PROPOSED LIDL FOODSTORE

**Former Hayes Pool and Fitness Centre,
Central Avenue, Hayes Town**

**Addendum Transport Assessment:
Appendices A - E
On behalf of Lidl UK**

Response to Highway Officer Comments

Drawing 15/0302/SK06

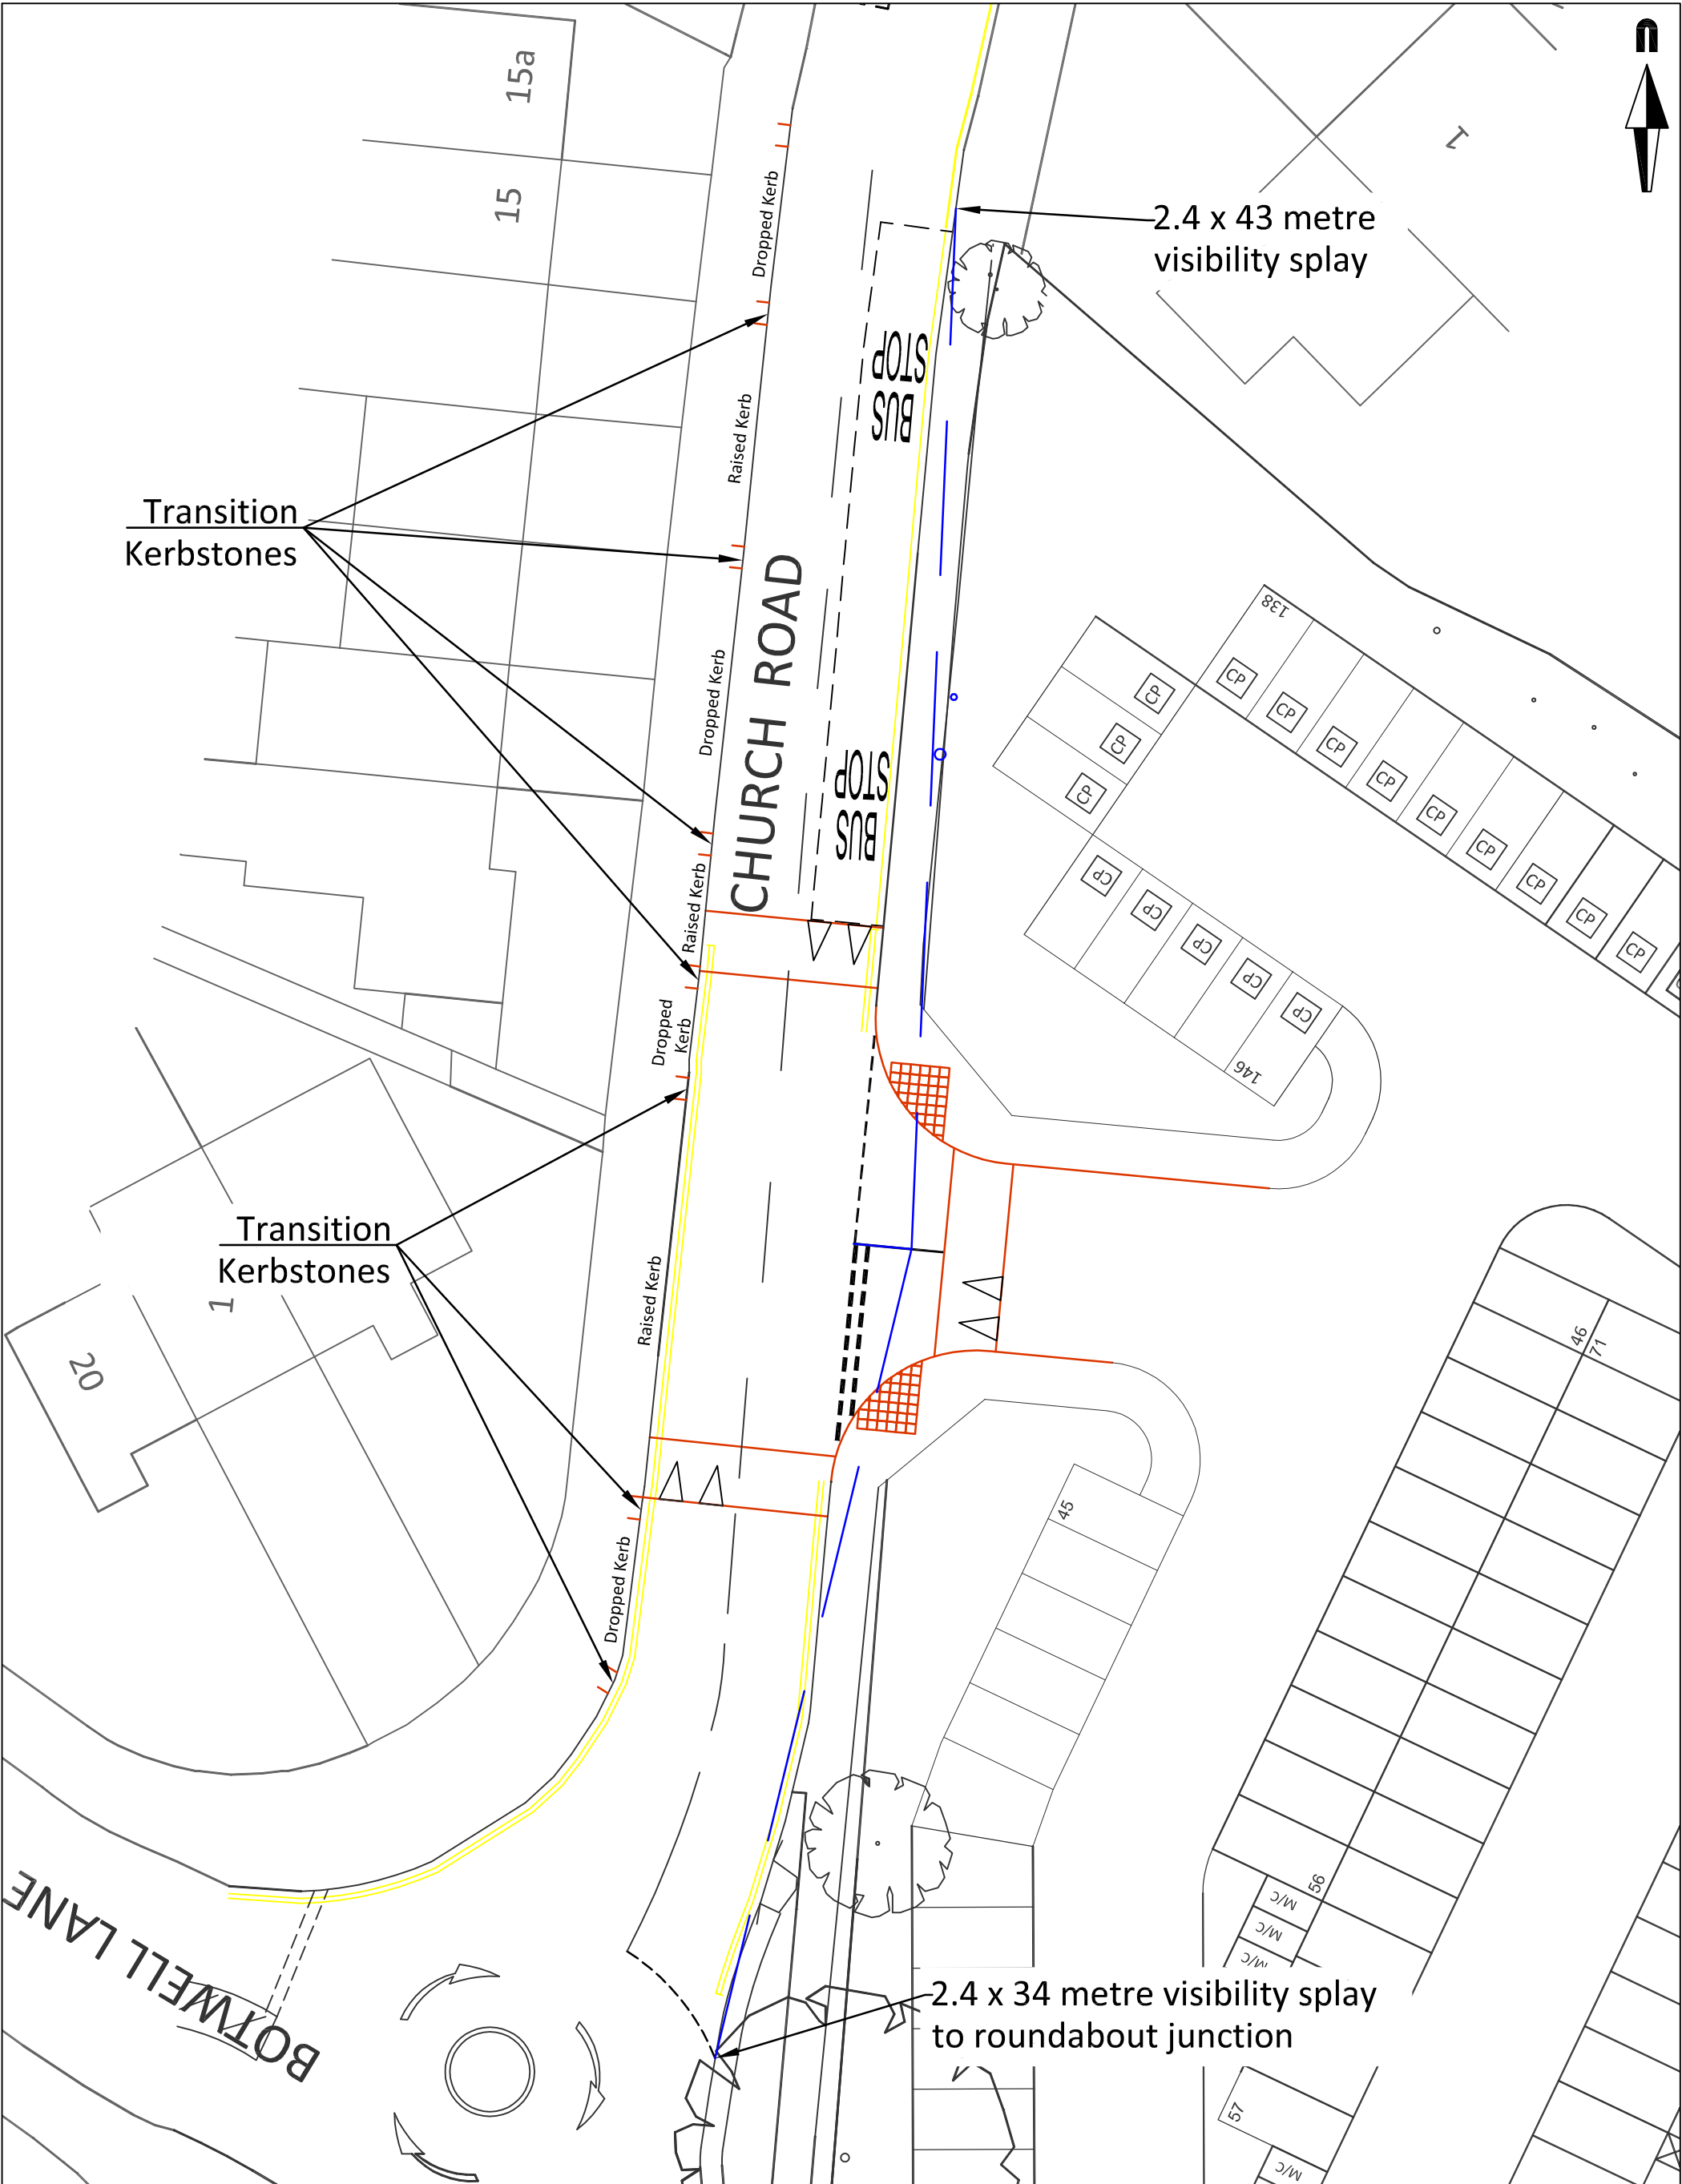
“Location of the proposed access in close proximity to the bus stop and vehicle crossover opposite is unsatisfactory due to concern relating to sightlines and conflicting traffic movements.”

- 4 To address the issues with visibility, two drawings have been created to provide the visibility splays associated with the proposed access arrangement. Drawing 15/0302/SK06, which is included at **Appendix A**, demonstrates the achievable visibility splays along Church Road, showing 2.4 by 43 metres to the north and 2.4 by 34 metres to the south, accounting for the proximity of the roundabout junction.

APPENDIX C
Site Access Junction - Extent of
Adoptable Highway

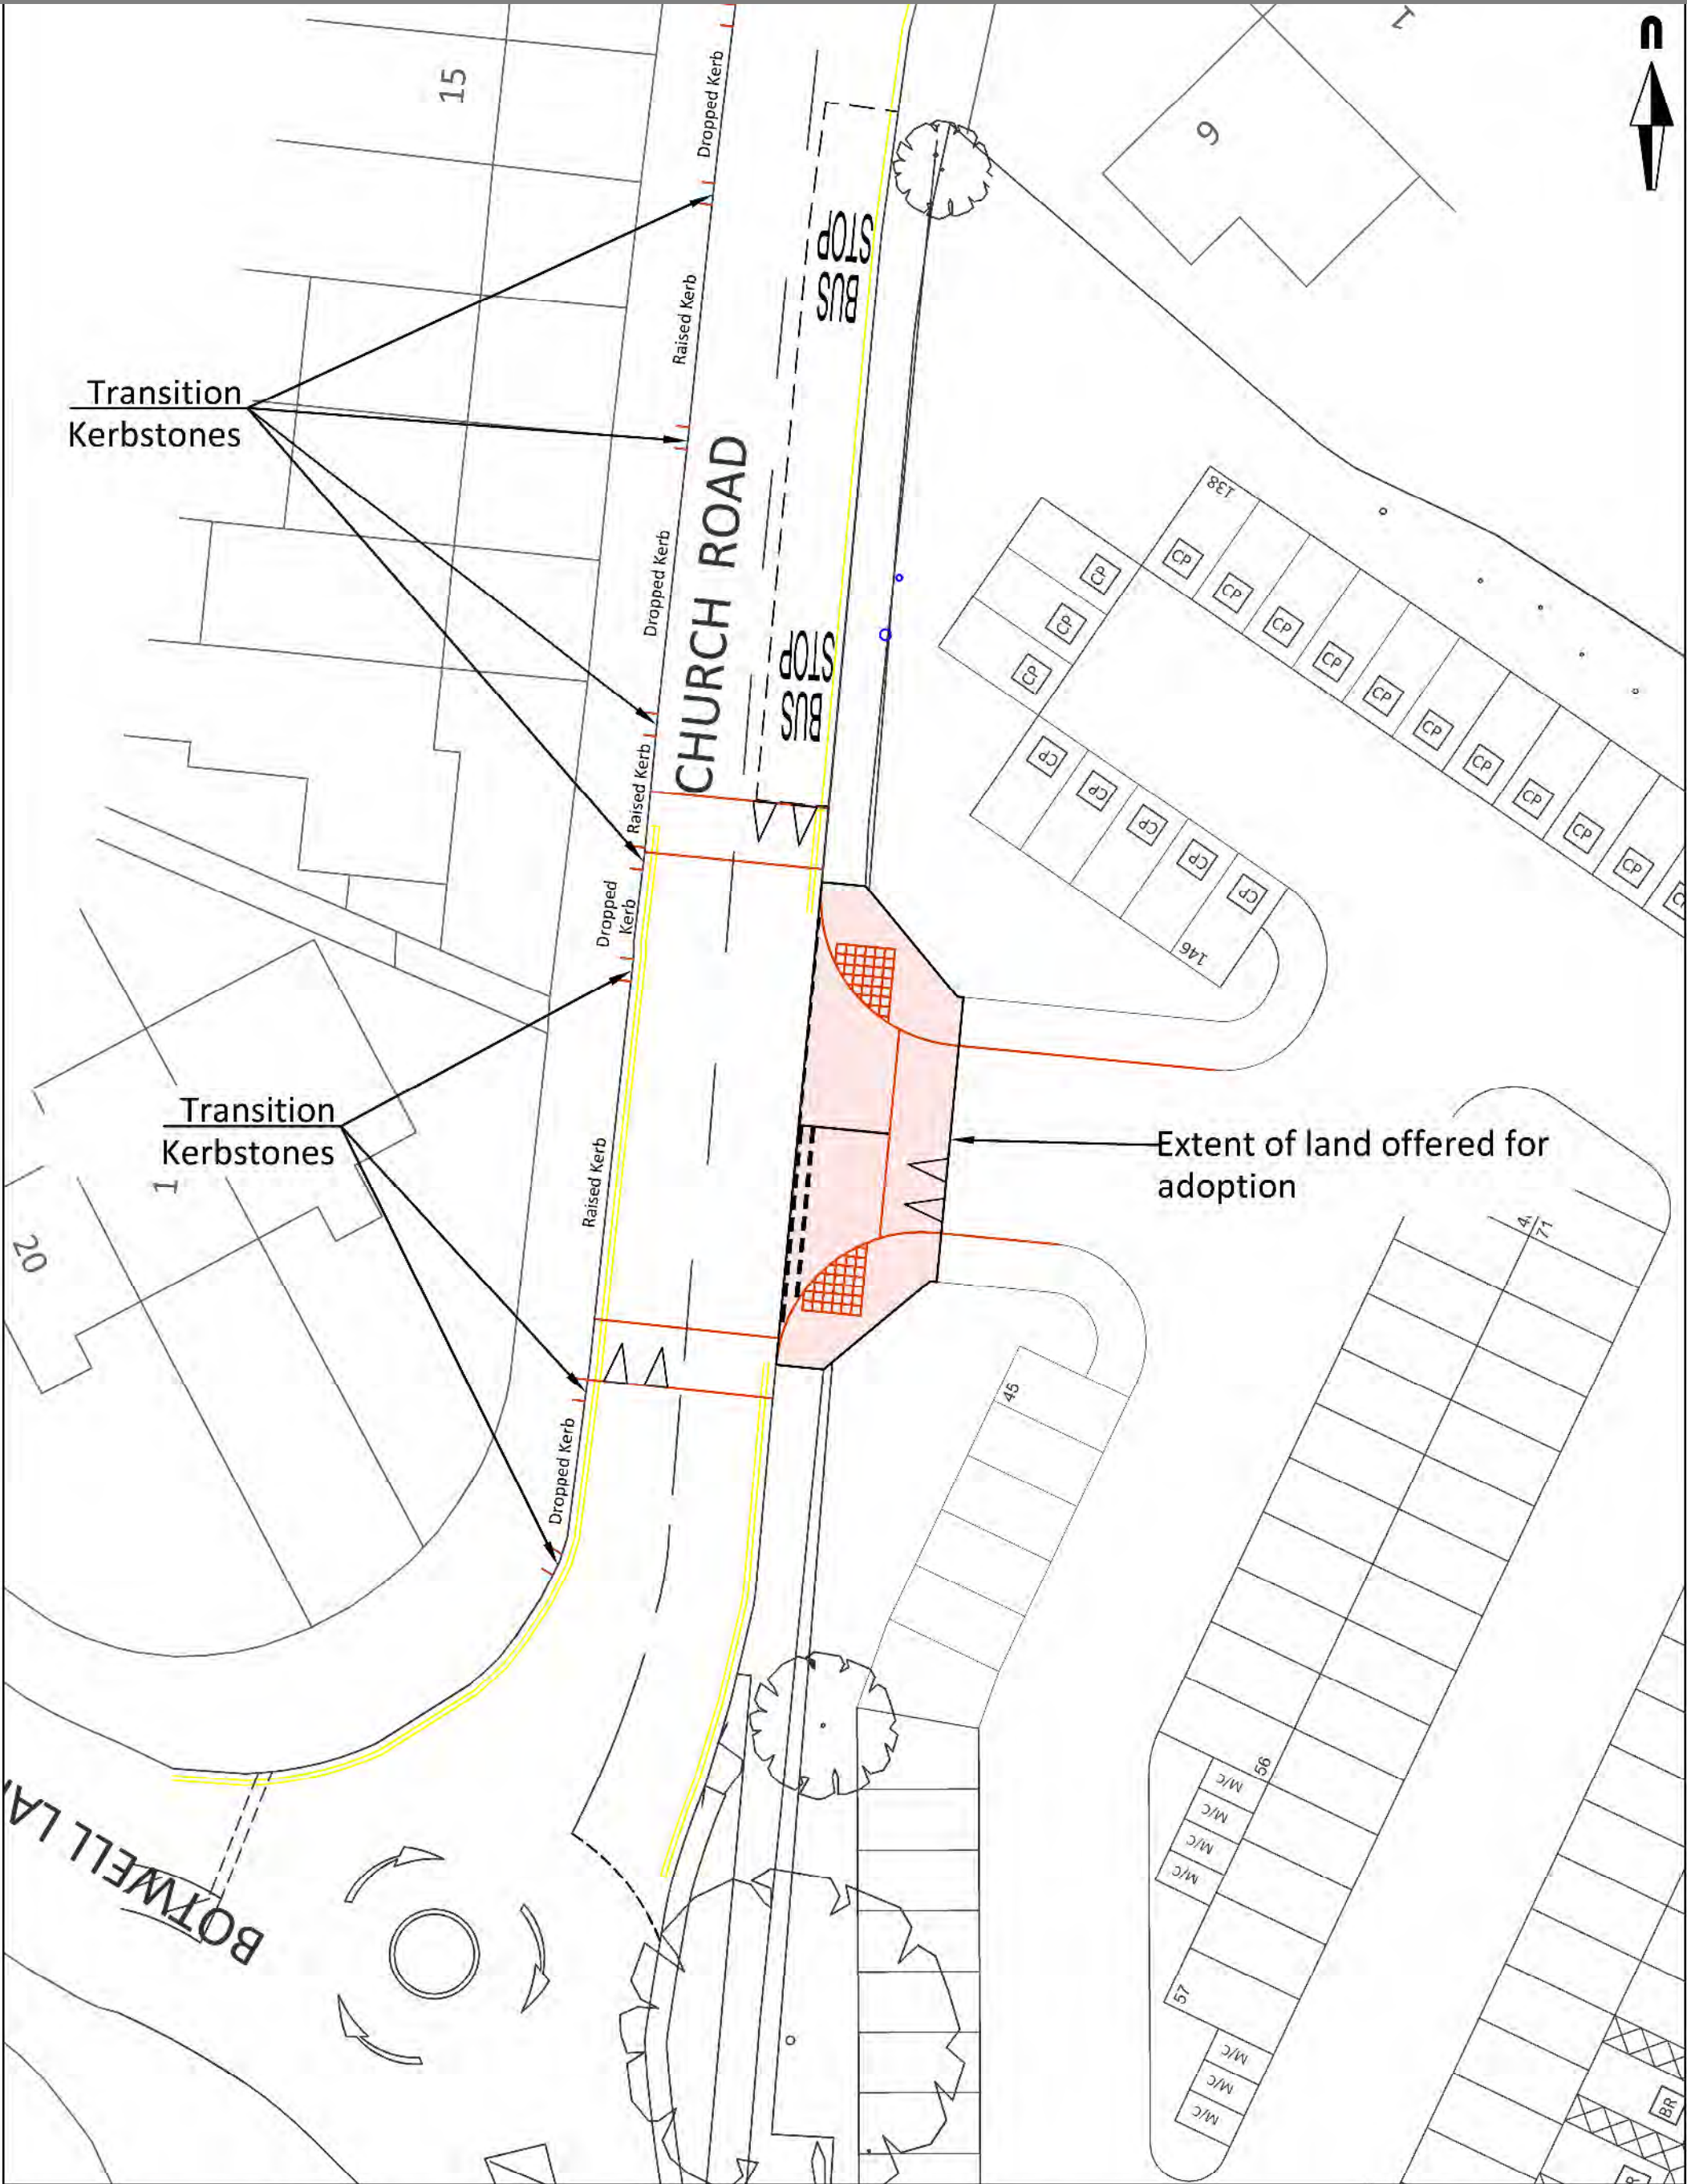
“The extent of land offered for adoption at the proposed access should be clarified; ensuring safe pedestrian crossing facility and surface drainage from private and public land are adequately addressed. “

- 12** It is considered that the extent of land offered for adoption would cover the entire raised table and ramp within the Lidl site. This is illustrated in an adoption extent drawing, included at **Appendix C**, which highlights the adoption boundary in red.
